APPLICATION NO.	FILING DATE	FIRST NAMED INVENTOR	ATTORNEY DOCKET NO.	CONFIRMATION NO.
10/689,141	10/20/2003	Richard J. Gilpatrick	039189-9074	2779

The following correspondence is a non-final Office Action for application # 10/689,141, entitled: Frame for pressurized fluid apparatus, filed on 10/20/2003. Claims 1, 3-4, 6-12, 14-18, 21, 36, and 43-51 are pending.

FIG. 1

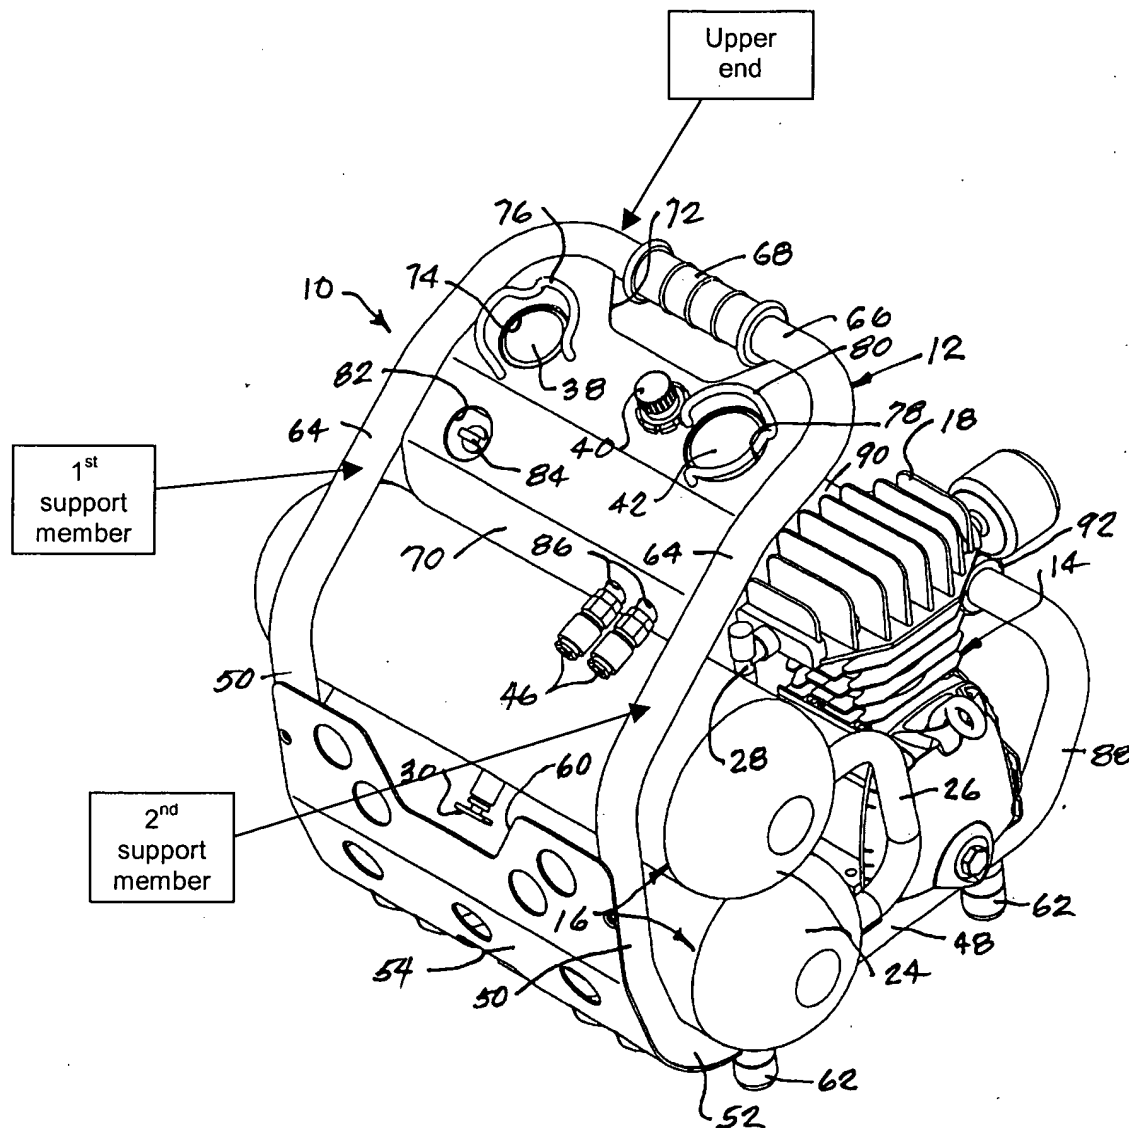
Regarding claim 1, Nolan discloses a frame, the frame comprising a base **48** that supports a power unit; at least one leg **62** that supports the base **48** on a surface; and a handle **66** configured to be used to move the frame from a first location to a second location, the handle **66** including an upper end, a first support member extending downwardly from the upper end, the first support member forming an acute included angle with the base **48** and a second support member extending downwardly from the upper end the second support member forming an acute included angle with the base **48**; where the first and second support members are integrally molded as one piece with the base **48** (as seen in Figs. 1 & 4 below).

Regarding claim 4, Nolan discloses the frame, where the base **48** includes an aperture therein configured to receive a portion of the power unit (as shown in Fig. 4 below).

With regards to claim 16, Nolan goes on to disclose the frame, where each of the support members forms an acute included angle with the base **48** (as shown in Fig. 4 below).

With regards to claim 43, Nolan discloses the frame, where the first support member has a first longitudinal axis and the second support member has a second longitudinal axis, where the first longitudinal axis forms an acute exterior angle with respect to the upper end of the handle **66**, and where the second longitudinal axis forms

an acute exterior angle with respect to the upper end of the handle **66** (see Fig. 4 below).

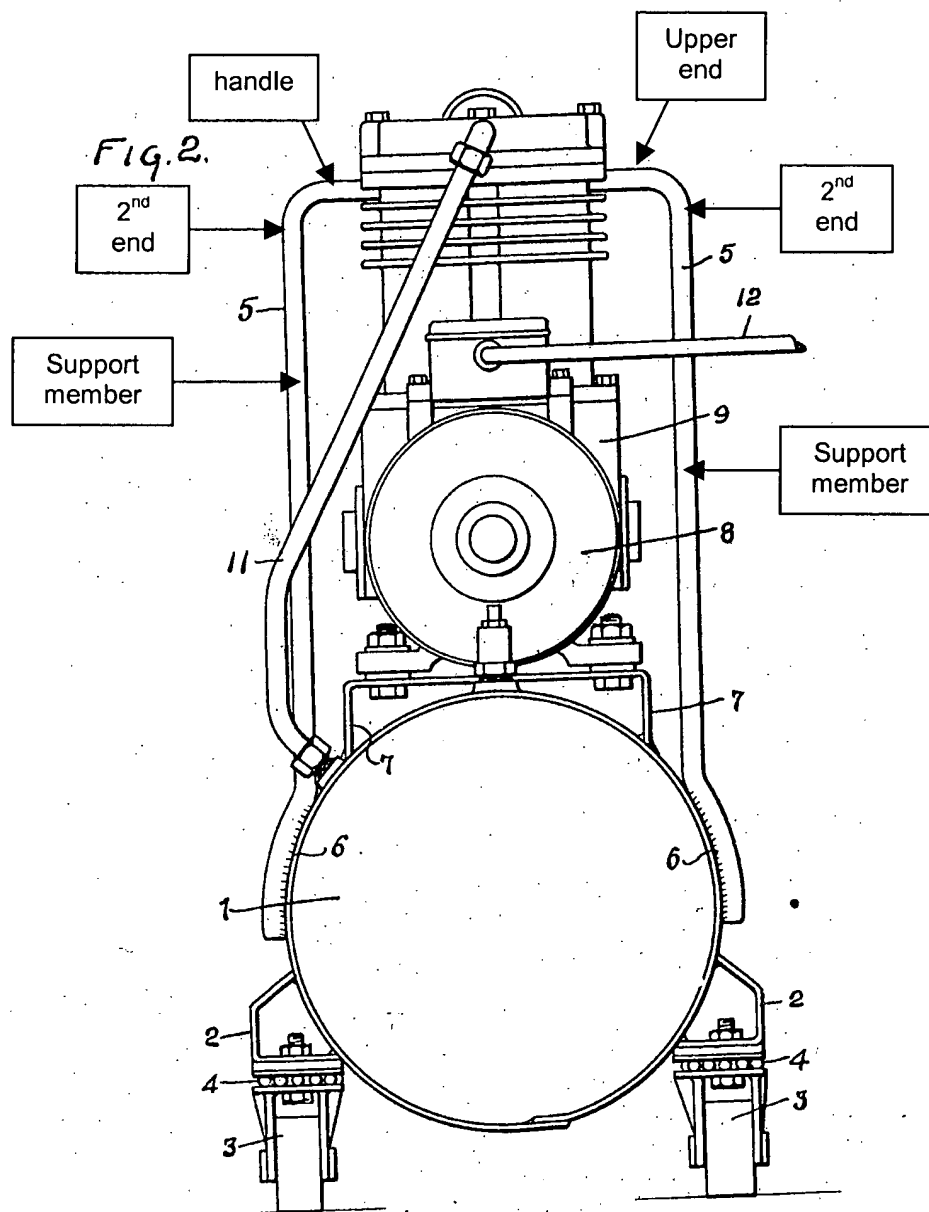
Regarding claim 46, Hobart discloses a frame comprising a base **1** that supports a power unit; at least one leg **2** that supports the base **1** on a surface; a handle configured to be used to move the frame from a first location to a second location, the handle including an upper end; and a pair of support members extending from the base **1**, each support member having a first end **6** near the base and a second end near the upper end of the handle, where a first width between the respective first ends of the support members is greater than a second width between the respective second ends of the support members (as shown in Fig. 2 below).
